ORIGINATION FORM

Proposed Revisions to a Standard Plans Index
(Please provide all information — Incomplete forms will be returned)

Index Number: 430-030
Sheet Number (s): 1 and 3 of 4
Index Title: Straight Concrete Endwalls Single and Multiple Pipe

Summary of the changes:

LAST REVISION 11/01/19	REVISION	DESCRIPTION:	 FY 2021-22 STANDARD PLANS	STRAIGHT CONCRETE ENDWALLS SINGLE AND MULTIPLE PIPE	INDEX 430-030	SHEET 1 of 4
--------------------------------------	----------	--------------	---	---	-------------------------	------------------------

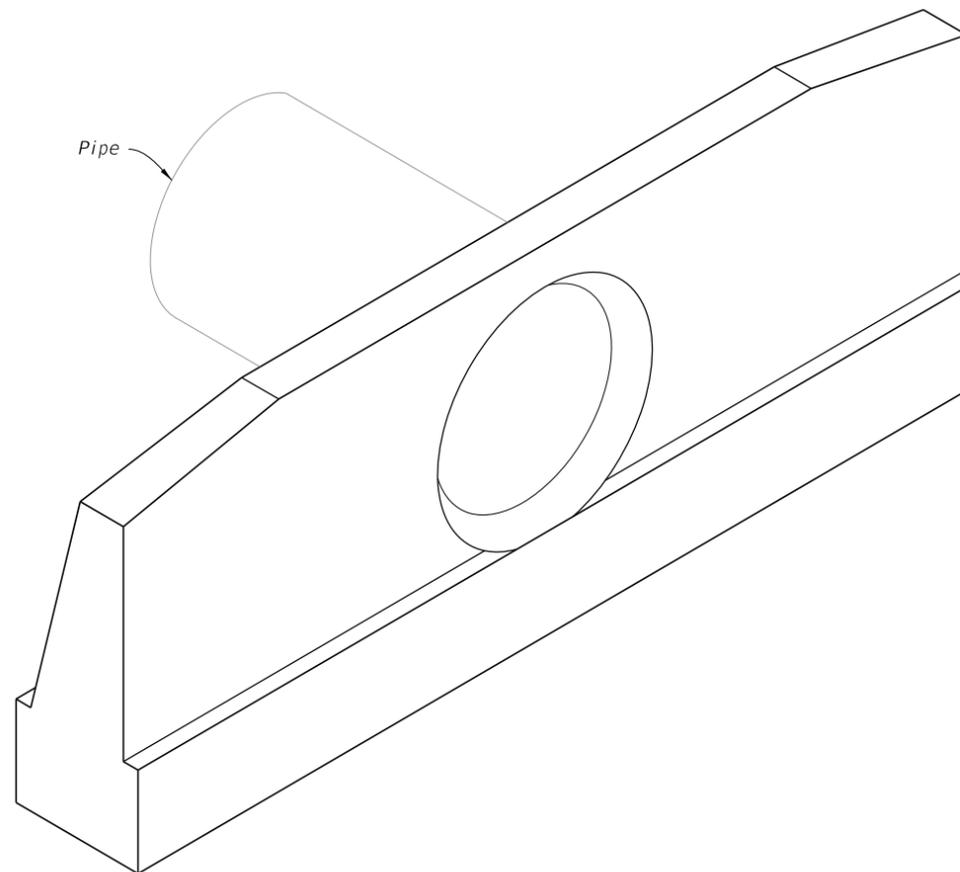
Sheet 1: Changed GENERAL NOTE 1 from "Class I" to "Class II".
Sheet 3: Changed "Class I" to "Class II" in both of the Tables.

CHANGED TO: Class II

1. Use ~~Class I~~ concrete.
2. ~~Reinforcing steel is~~ either Grade 40 or 60.
3. Endwalls may be cast in place or precast concrete. (Additional reinforcement necessary for handling precast units will be determined by the Contractor or the supplier).
4. Chamfer all exposed edges and corners to $\frac{3}{4}$ ".
5. Endwall dimensions, locations and positions are for round and elliptical concrete pipe and for round and pipe-arch corrugated metal pipe. Round concrete pipe shown.
6. On outfall ditches with side slopes flatter than 1:1.5 provide 20' transitions from the endwall to the flatter side slopes, right of way permitting.
7. Construct front slope and ditch transitions in accordance with Index 430-001.
8. Quantities shown are for estimating purposes only.

LAST REVISION 11/01/21	DESCRIPTION:	FY 2022-23 STANDARD PLANS	INDEX 430-030	SHEET 3 of 4
---------------------------	--------------	------------------------------	------------------	-----------------

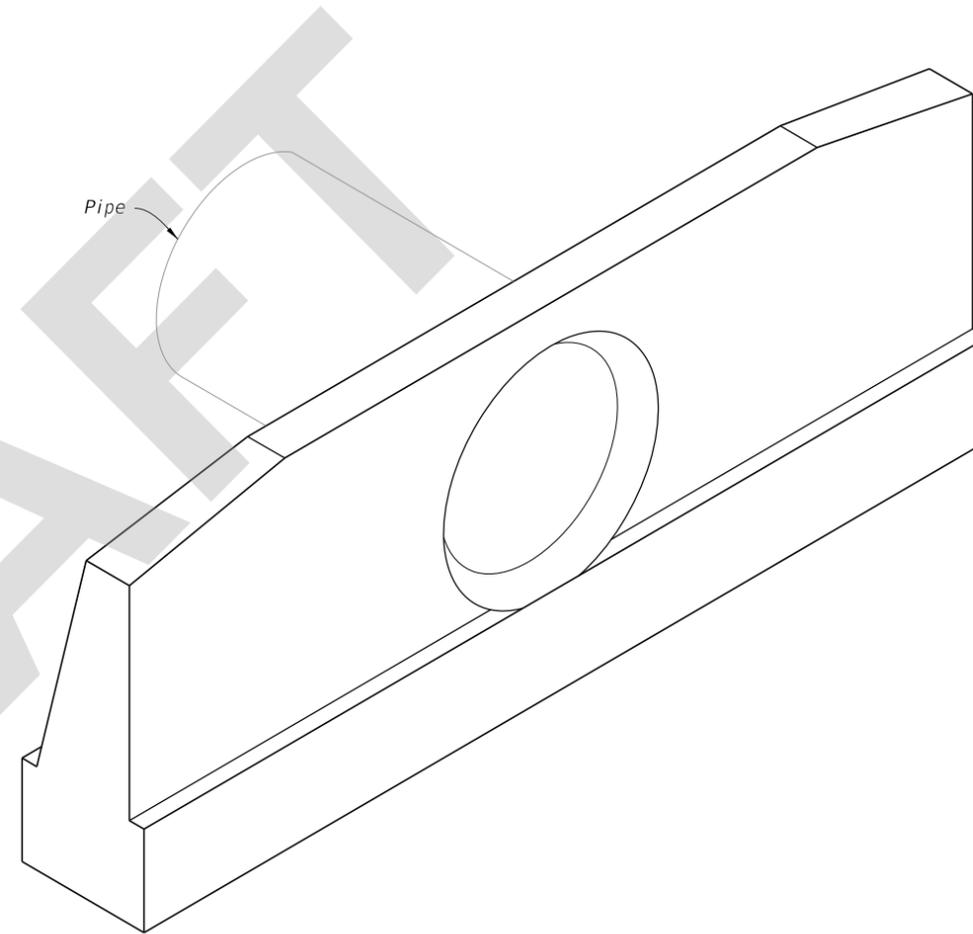
CHANGED TO: Class II

1. Use Class II concrete.
2. Reinforcing steel is either Grade 40 or 60.
3. Endwalls may be cast in place or precast concrete. (Additional reinforcement necessary for handling precast units will be determined by the Contractor or the supplier).
4. Chamfer all exposed edges and corners to $\frac{3}{4}$ ".
5. Endwall dimensions, locations and positions are for round and elliptical concrete pipe and for round and pipe-arch corrugated metal pipe. Round concrete pipe shown.
6. On outfall ditches with side slopes flatter than 1:1.5 provide 20' transitions from the endwall to the flatter side slopes, right of way permitting.
7. Construct front slope and ditch transitions in accordance with Index 430-001.
8. Quantities shown are for estimating purposes only.
